Item Name: Crosstube Turning Detail

DART AEROSPACE LTD		Work Order:	137024
Description: Crosstube Assembly		Part Number:	D206-667-243
Inspection Dwg: D206-667-243 Rev: C		Page 1 of 2

DESIGN	97	DART AEROSPACE LTD	
DRAWN	RF	HAWKESBURY, ONTARIO, CANADA	
CHECKED	97	DRAWING NO.	REV. C
MFG. APPR.	97	D206-667-243	SHEET 2 OF 4
APPROVED	97	TITLE	SCALE
DE APPR.	97	CROSSTUBE ASS'Y (206L HIGH AFT)	NTS
DATE	08.11.06	COPYRIGHT © 2000 BY DART AEROSPACE LTD THIS DOCUMENT IS PRIVATE AND CONFIDENTIAL AND IS SUPPLIED ON THE EXPRESS CONDITION THAT IT IS NOT TO BE USED FOR ANY PURPOSE OR COPIED OR COMMUNICATED TO ANY OTHER PERSON WITHOUT WRITTEN PERMISSION FROM DART AEROSPACE LTD.

DRAWING NO. D206-667-243	TITLE CROSSTUBE ASS'Y (206L HIGH AFT)	REV. C	DART AEROSPACE LTD ENGINEERING ORDER		D.E.O. NO. D206-667-243-C-1	SHEET NO. SHEET 1 OF 1	SCALE NTS
DRAWN <i>q</i>	CHECKED <i>ASS</i>	MFG. APPR. <i>RB</i>	APPROVED <i>MD</i>		DE APPR. <i>#</i>		
DATE 11.07.15	DATE 11.07.20	DATE 11.07.21	DATE 11/07/21		DATE 11.07.21

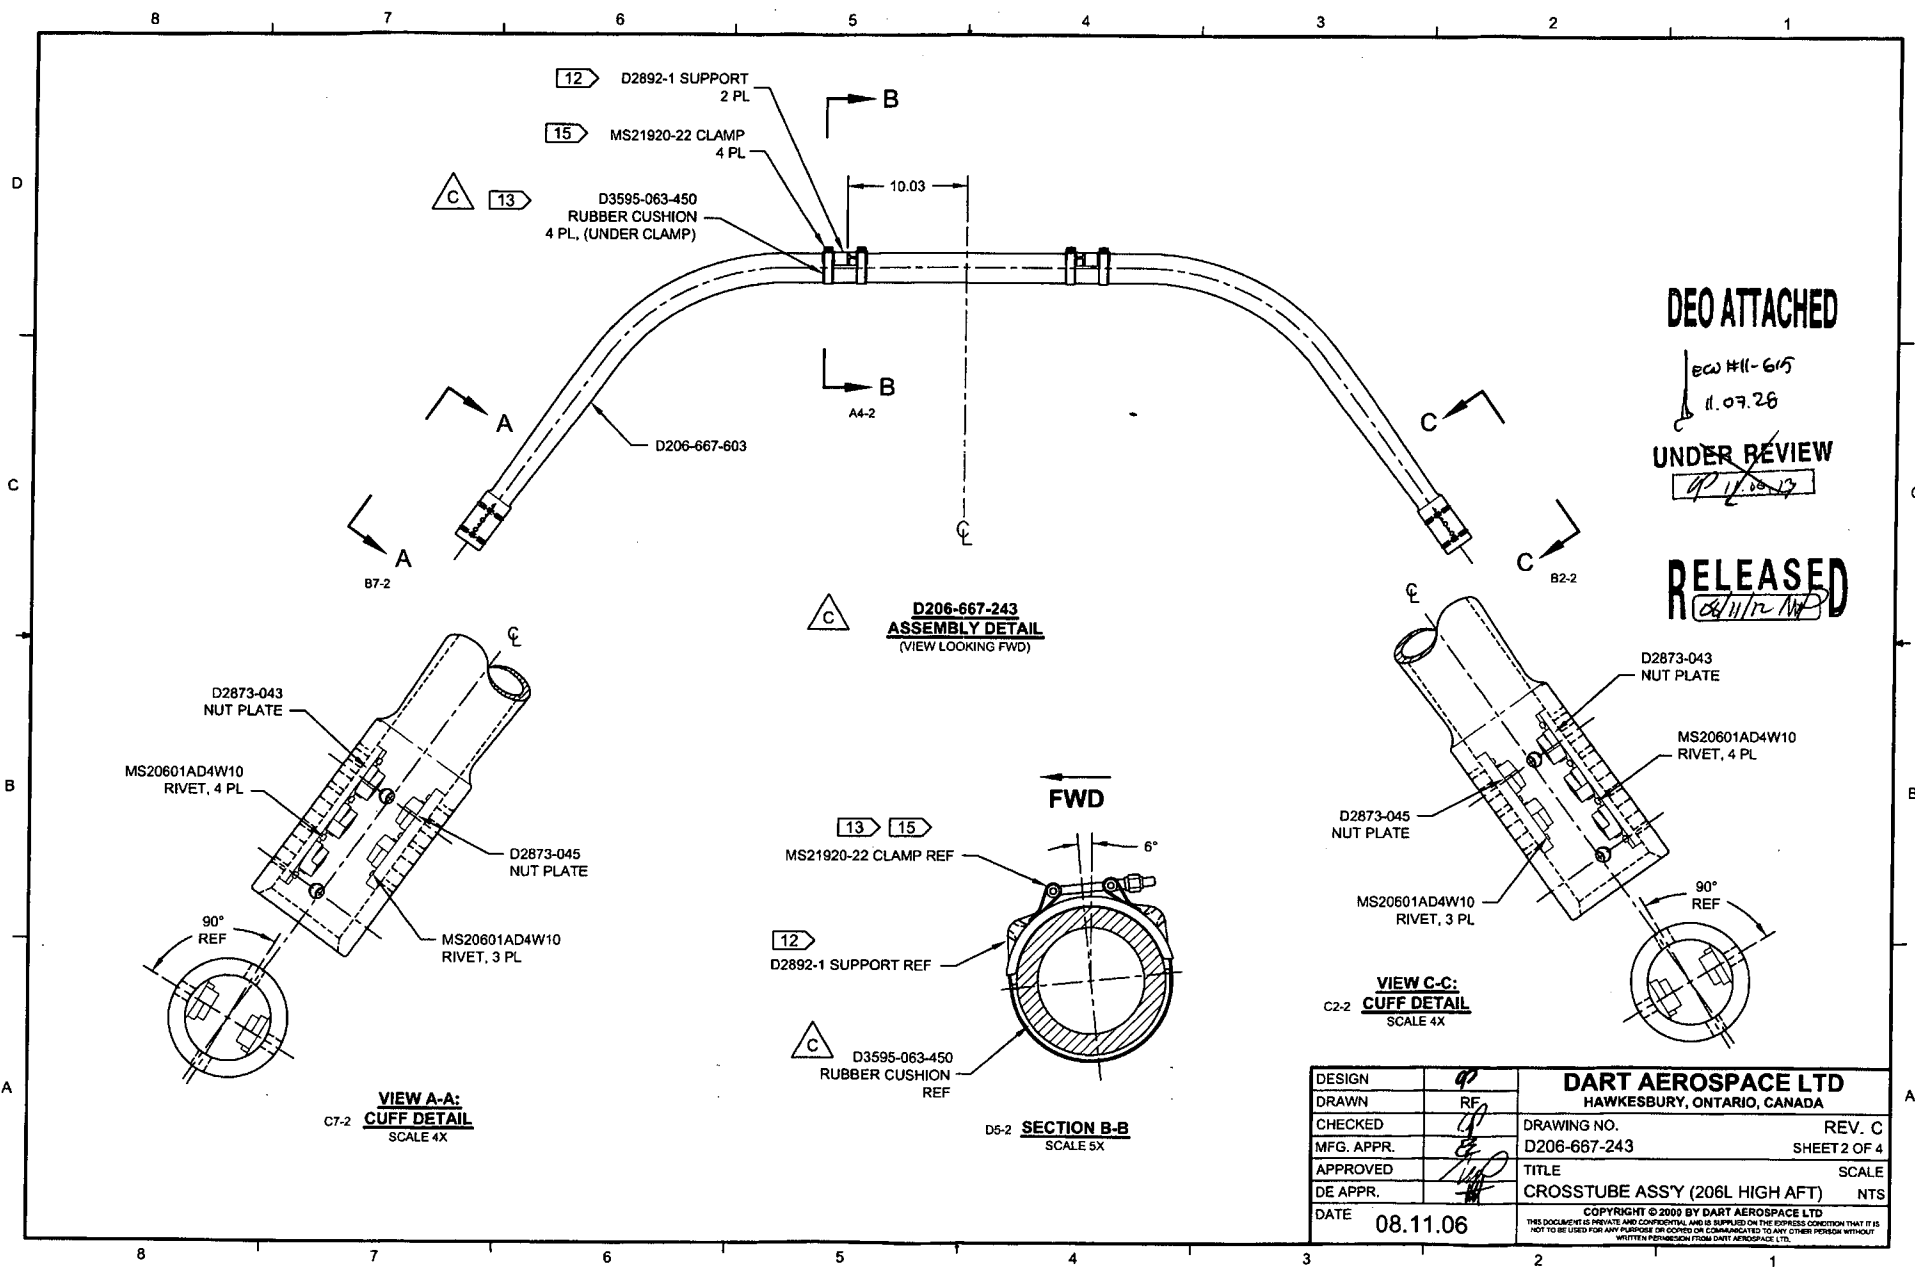
PURPOSE:

REPLACE MAGNOBOND WITH PROSEAL.

NOTE 12 & 15, SHEET 1 IS AMENDED AS FOLLOWS:

Item	Qty -243	Part Number	Description
9	A/R	PROSEAL 890 B-2	SEALANT, AMS-S-8802 CLASS B-2

12) TO INSTALL D2892-1 SUPPORT: ABRABE MATING SURFACE OF SUPPORT AND CROSSTUBE WITH 180-GRIT SANDPAPER AND REMOVE RESIDUE WITH MEK (OR EQUIVALENT). APPLY A 0.04" TO 0.07" THICK LAYER OF PROSEAL 890 CLASS B-2 (OR AMS-S-8802 CLASS B-2) SEALANT TO MATING SURFACE OF SUPPORT.

15) TORQUE CLAMPS 80 TO 100 IN-LB. ENSURE AT LEAST 1.5 THREADS SHOWING IN SAFETY AND THAT NUT HAS NOT BOTTOMED-OUT AFTER TORQUING. **PRIOR TO PACKAGING, RE-CHECK TORQUE ON CLAMPS AFTER PROSEAL 890 SEALANT HAS CURED FOR 72 HOURS.**
